# **A1 in Northumberland: Morpeth to Ellingham**

**Scheme Number: TR010059**

## **Summary of Proposed Changes to Application**

<b>Regulation Reference:</b>	Infrastructure Planning (Examination Procedure) Rules 2010
<b>Planning Inspectorate Scheme Reference</b>	TR010059
<b>Document Reference</b>	TR010059/7.5
<b>Author:</b>	A1 in Northumberland: Morpeth to Ellingham Project Team, Highways England

## Permanent Works at the River Coquet

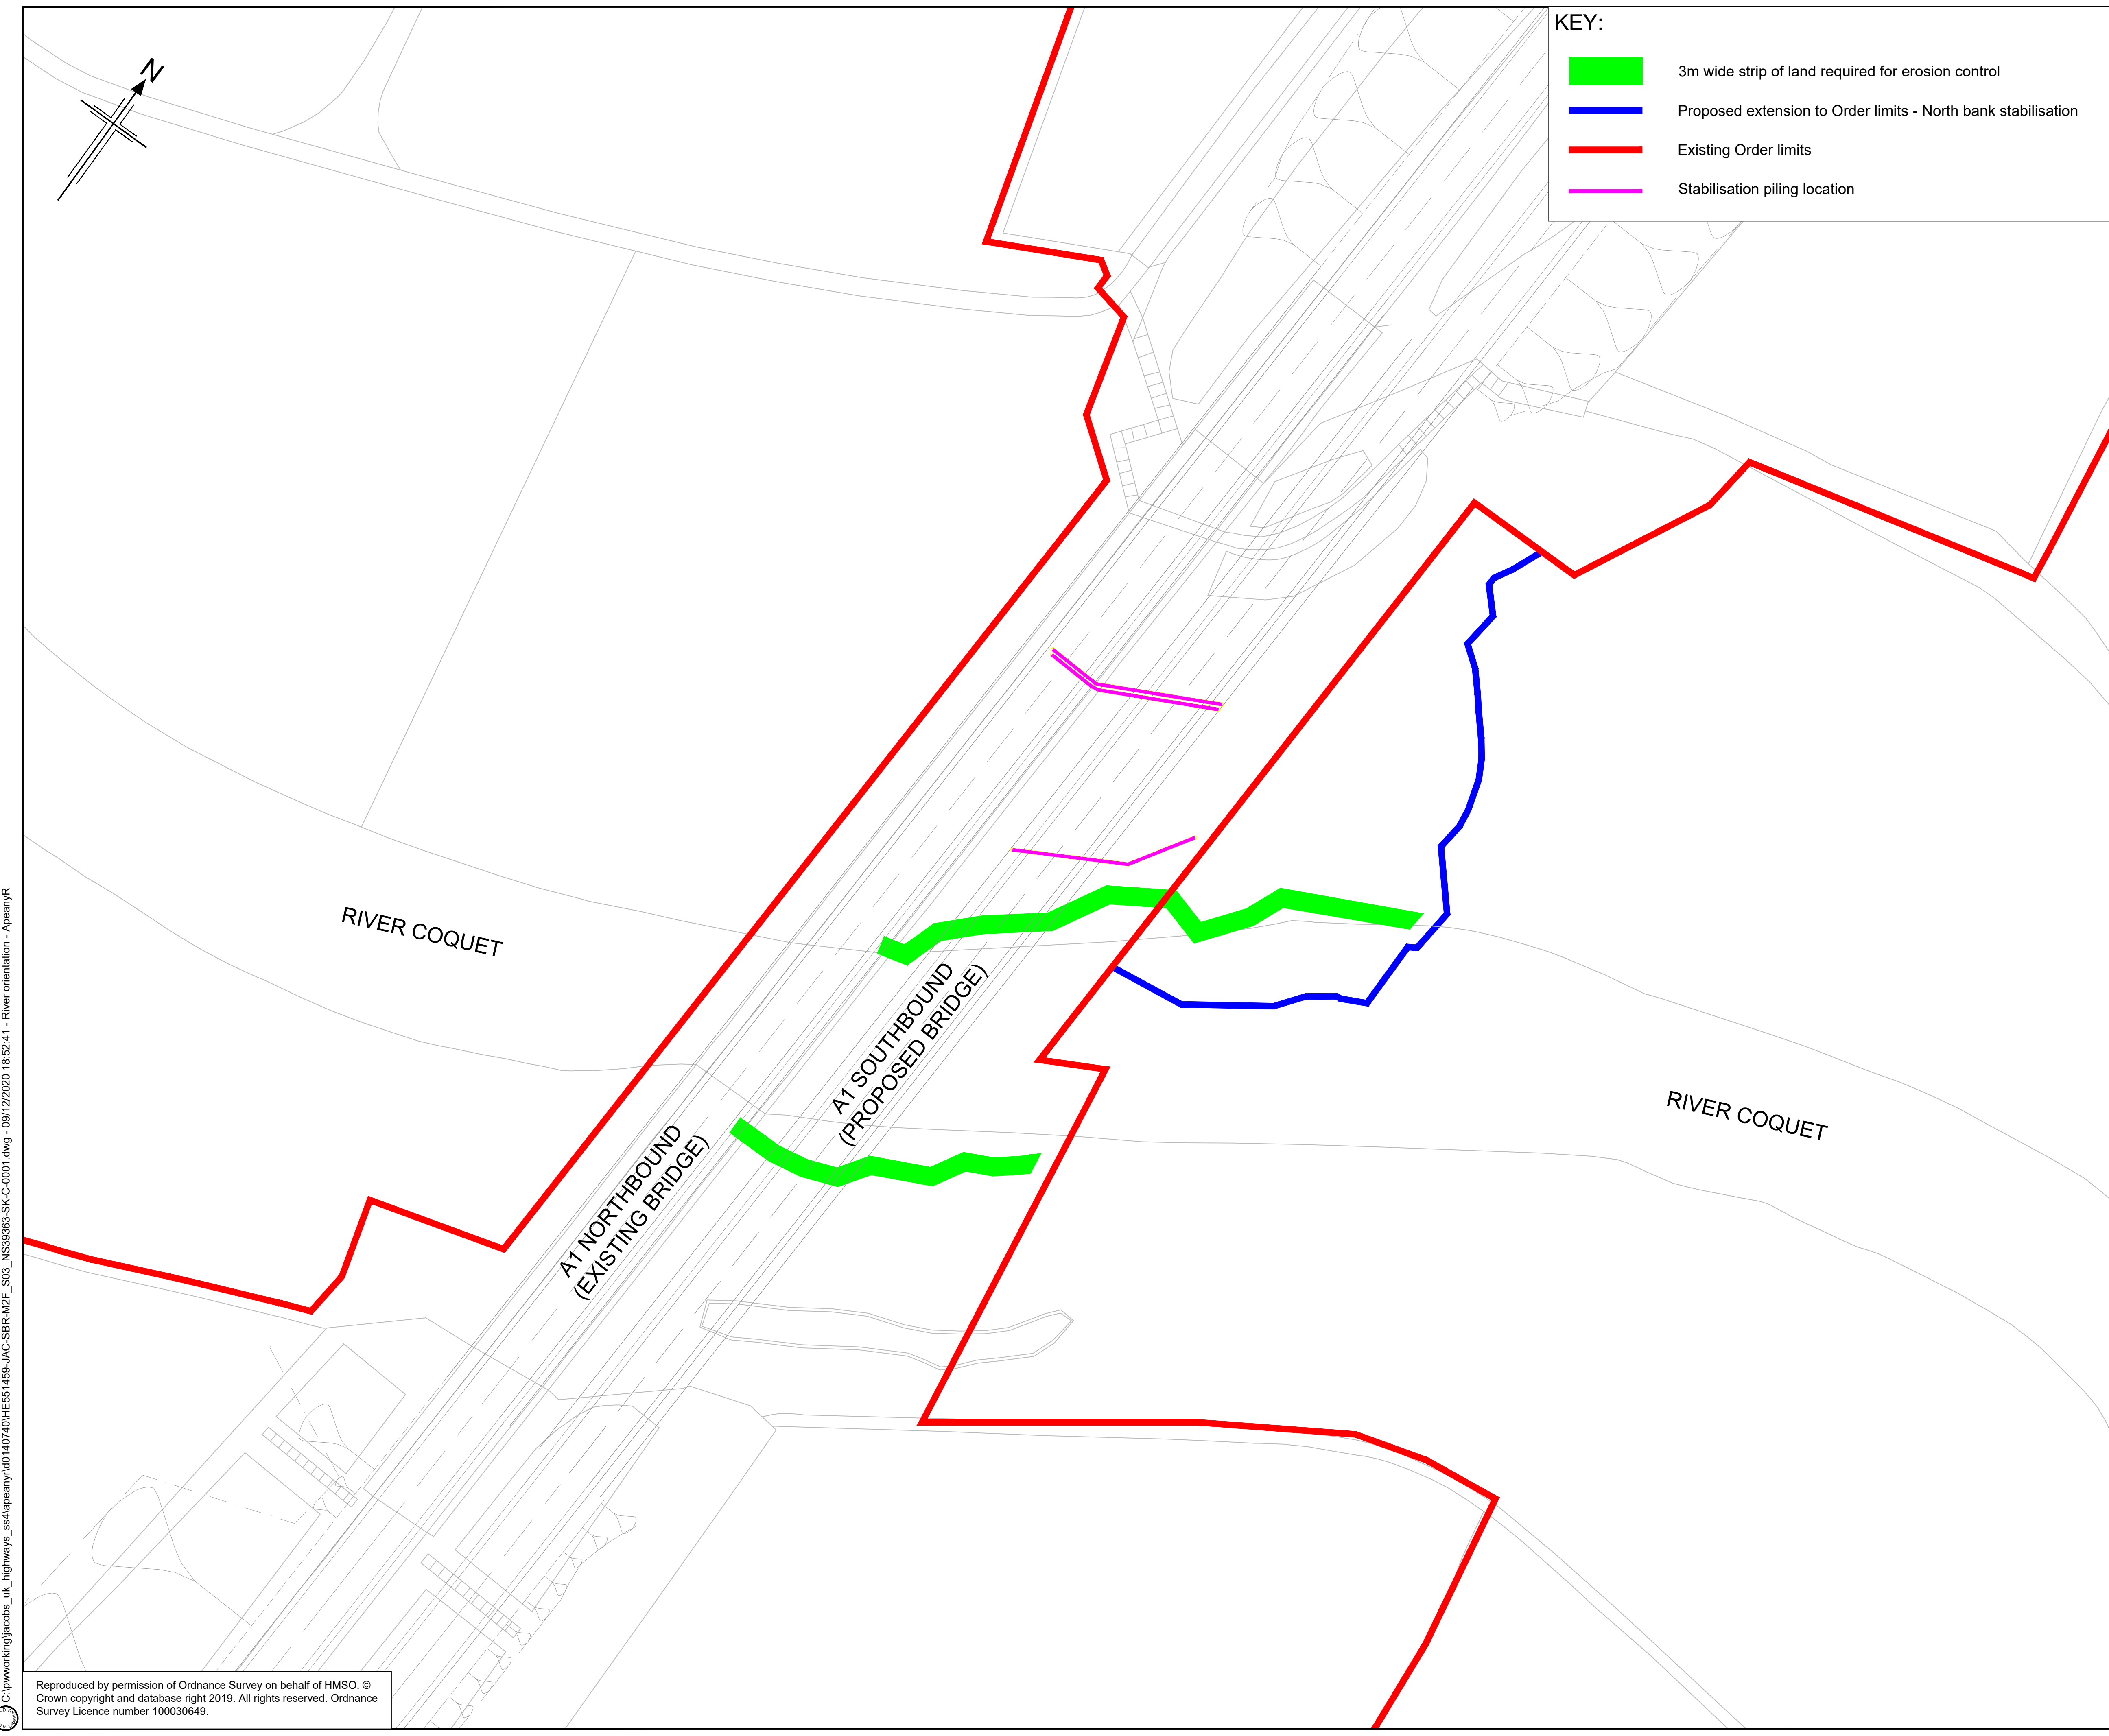
- 2.2.4 The proposal would comprise two rows of spaced piles to the north side of the proposed pier location and a third row to the south side as shown in the **Permanent Works at the River Coquet** figure in **Appendix A**. All of the permanent piling works are currently proposed to stay within the existing Order limits of Part A. However, carrying out the piling works within the existing Order limits of Part A would present engineering challenges. It is therefore necessary to expand the Order limits to provide temporary working areas in order to ensure that the proposed stabilisation construction works can be carried out.

- 2.2.11 For the purposes of understanding how the proposed land stabilisation north of the River Coquet differs from those already contained in the Application, drawings of the proposed stabilisation works are provided in the **Permanent Works at the River Coquet** figure in **Appendix A**.
